## Amendments to the Drawings:

Application No. 10/625,576 Amendment Dated April 7, 2004 Reply to Office Action of March 23, 2004 Annotated Sheet Showing Changes

See CASE. AS FILED; P.21 Fig. 4 ALSO

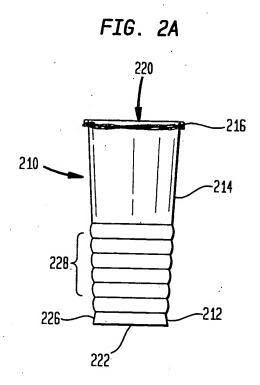
On Figure 1A, it is proposed to show inner diameter 32 more accurately as well as height 35 and width 31 of the rim. These proposed changes conform the drawing better to the text at p. 21, lines 4-26:

Tumbler 10 is optionally provided with a molded-in design 28 which is more clearly seen by reference to Figures 1(b) and 1(c). Base sidewall 26 extends upwardly to define an outer edge 30 which attaches to sidewall 14. Sidewall 14 extends upwardly to fortified rim 16. Rim 16 is integrally formed with sidewall 14 and is a continuous generally circular or oval, solid polymer bead extending about periphery 18 of opening 20. Rim 16 has a width 31 which is defined by the difference between an inner diameter 32 and an outer diameter 34 of rim 16 and a height 35 which is the distance over which width 31 extends. Width 31 is thicker than adjacent sidewall portion 38 which is typically of the same caliper as the reset of sidewall 14. In the example shown in Figures 1(a) – 1(c), adjacent sidewall portion 38 has a thickness of 10 mils, height 35 is approximately 28 mils and width 31 is approximately 40 mils at its thickest point.

Other dimensions of tumbler 10 are indicated on Figure 1A. Base portion 12 has a diameter D, at edge 30 of about 2.125 inches, an outer upper diameter 34 of 2.770 inches an inner upper diameter 32 of 2.730 inches. The overall height, H, of tumbler 10 is 5.785 inches. These dimensions define an angle of taper T as shown about imaginary central axis 40 of about 3° for sidewall 14 of tumbler 10. As used herein "taper", "degree of taper" and like terminology indicates the angle that the sidewall of the inventive tumbler makes with the imaginary central longitudinal axis defined by the sidewall which is substantially perpendicular to bottom 22, the taper of the article may also be thought of as the angle the sidewall makes with the bottom less 90 degrees.

SEE P. 23 FIG.Y

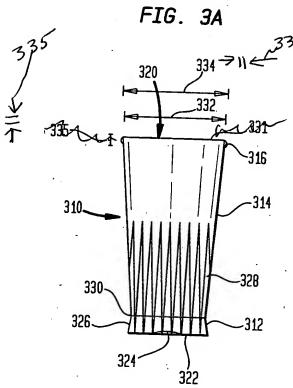
On Figure 3A, thickness 331 and height 335 of the rim should be shown as on Figure 1. Also, the rim should be shown as in Figures 1 and 2. These changes are supported by the specification as filed at p. 23, lines 8-20:

Base sidewall 326 extends upwardly to define an outer edge 330 which attaches to sidewall 314. Sidewall 314 extends upwardly to fortified rim 316. Rim 316 is integrally formed with sidewall 314 and is a continuous generally circular or oval, solid polymer bead extending about periphery 318 of opening 320. Rim 316 has a width 331 which is defined by the difference between an inner diameter 332 and an outer diameter 334 of rim 316 and a height 335 which is the longitudinal distance over which width 331 extends. Width 331 is thicker than adjacent sidewall portion 338 which is typically of the same caliper as the rest of sidewall 314. In the example shown, adjacent sidewall portion 338 has a thickness of 20 mils height 335 is approximately 28 mils and width 331 is approximately 40 mils at its thickest point.

FIG. 5

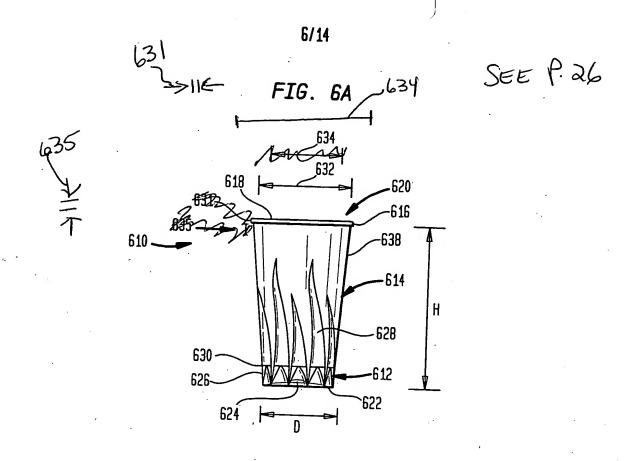
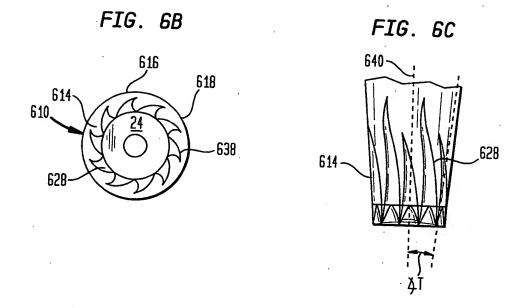
The fortified rim 516, Figure 5, should appear schematically the same as in Figures 4A, 4B.

SEE p.27-28

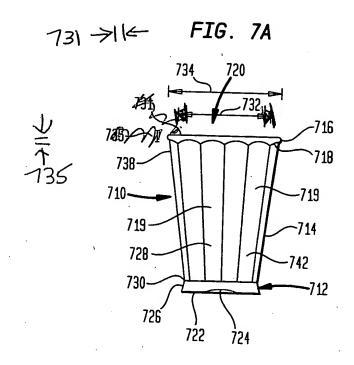
Figure 7A should be conformed to Figures 1A, 2A, 3A and 6A. These changes conform the Figure to the text at the bottom of page 27 and top of page 28:

Rim 716 is integrally formed with sidewall 714 and is a continuous generally circular or oval, solid polymer bead extending about periphery 718 of opening 720. Rim 716 has a width 731 which is defined by the difference between an inner diameter 732 and an outer diameter 734 of rim 716 and a height 735 which is the distance over which width 731 extends. Width 731 is thicker than adjacent sidewall portion 738 which is typically of the same caliper as the rest of sidewall 714. In the example shown, adjacent sidewall portion 738 has a thickness of 20 mils, height 736 is approximately 28 mils and width 731 is approximately 40 mils at its thickest point.

SEE P.29

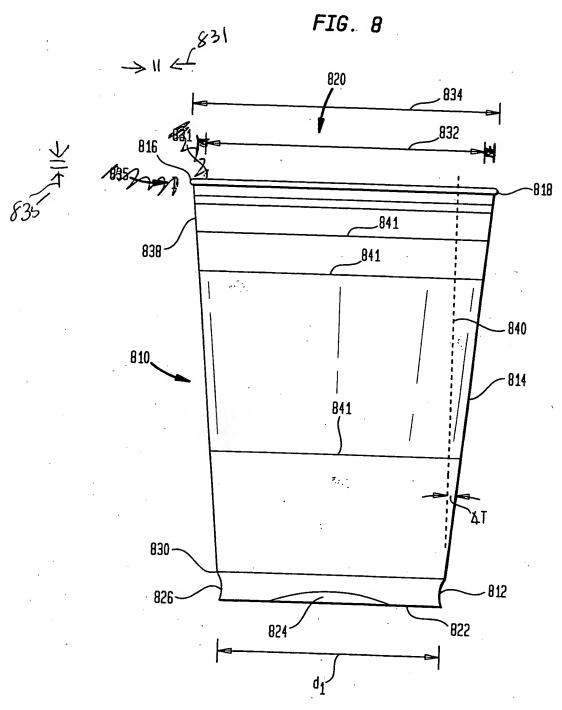
Figure 8 should be consistent with the other tumblers and text at page 29, beginning on line 10:

Base sidewall 826 extends upwardly to define an outer edge 830 which attaches to sidewall 814. Sidewall 814 extends upwardly to fortified rim 816. Rim 816 is integrally formed with sidewall 814 and is a continuous generally circular or oval, solid polymer bead extending about periphery 818 of opening 820. Rim 816 has a width 831 which is defined by the difference between an inner diameter 832 and an outer diameter 834 of rim 816 and a height 835 which is the distance over which width 831 extends. Width 831 is thicker than adjacent sidewall portion 838 which is typically of the same caliper as the rest of sidewall 814, that is, sidewall 814 is substantially uniform in thickness on the entire tumbler. In the example shown, adjacent sidewall portion 838 has a thickness of 20 mils, height 835 is approximately 28 mils and width 831 of rim 816 is approximately 28 mils and width 831 of rim 816 is approximately 40 mils at its thickest point. The tumbler is also provided with a series of molded-in grooves 841 which extend around the tumbler. These grooves

provide a grip for a user as well as providing rigidity to the article. Typically, the circumferential grooves 841 have a depth of from 810 to 40 mils.

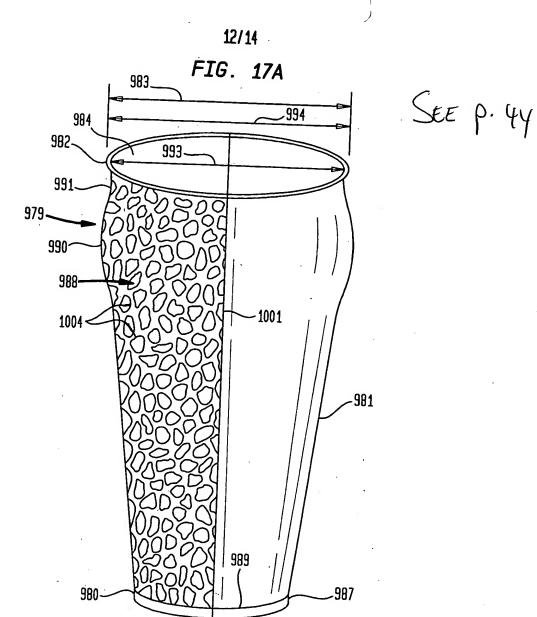
Finally, on **Figure 17A**, lines **1004** should extend to the edge of the embossed area as noted on p. 44, lines 5-7:

For example, tumbler 979 can optionally be provided with an embossing design defined by embossed flat surfaces 988 and ridges 1004 which circumscribe the embossed areas 988.
